**PCN# : P61DAAB**  
**Issue Date : Feb. 02, 2016**

**Information Only Notification**

**Figure 2. Functional Block Diagram**

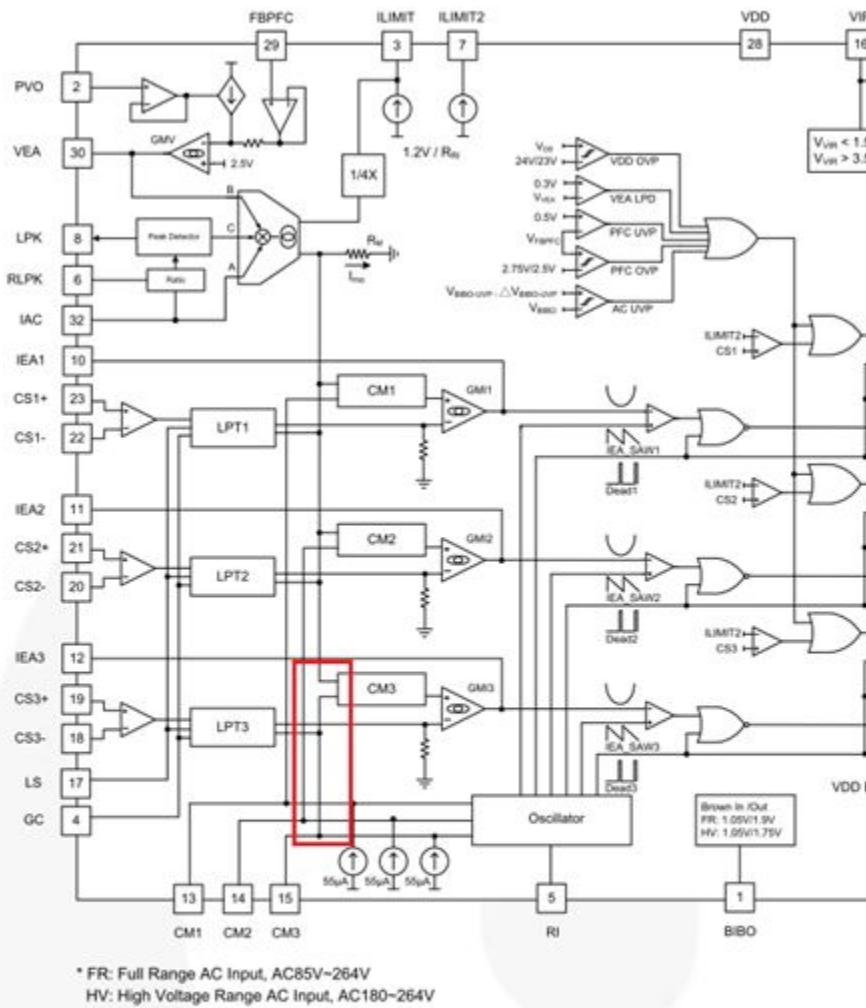
1. Ordering Information only has FAN9673Q (page 1)
2. Functional Block Diagram (Figure 2)

**Figure 2. Functional Block Diagram**

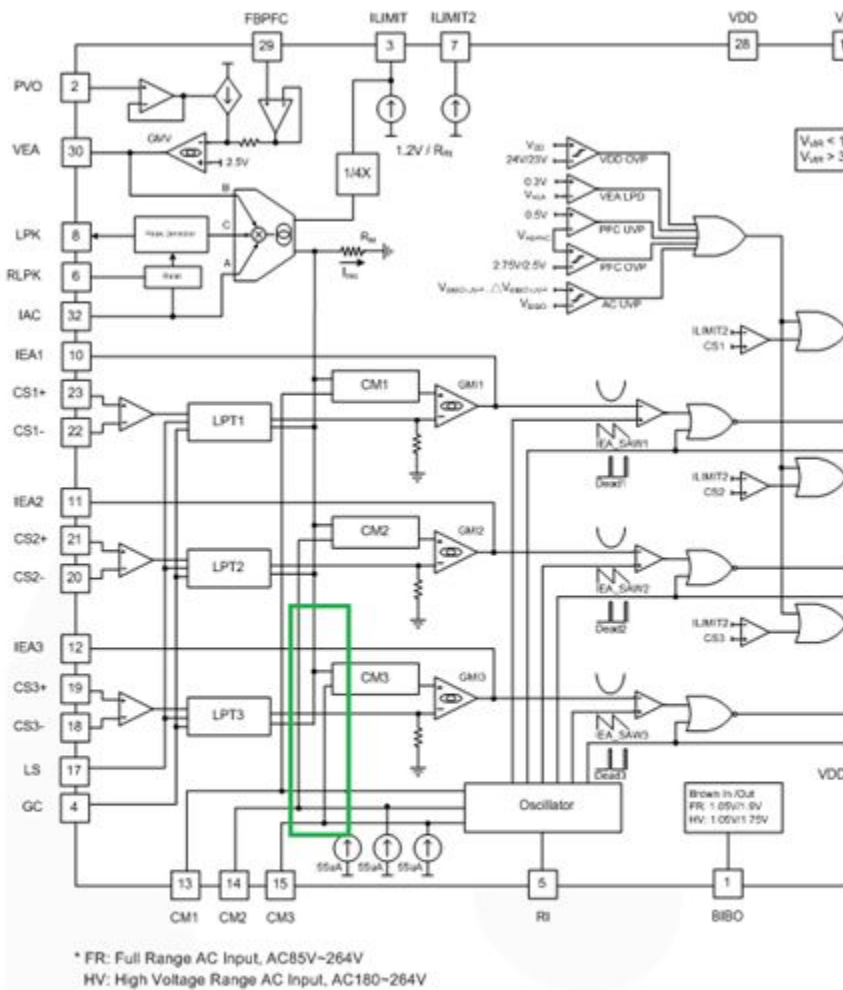
- 1.Ordering Information, Add new Part Number (FAN9673QX) with Tape and Reel Packing method (Page 1)
2. Functional Block Diagram (Figure 2) Fixed connection wire from LPT3 to CM3 (See attached diagram)

- 1.Released new part number
- 2.Corrected typo in Figure 2 drawing
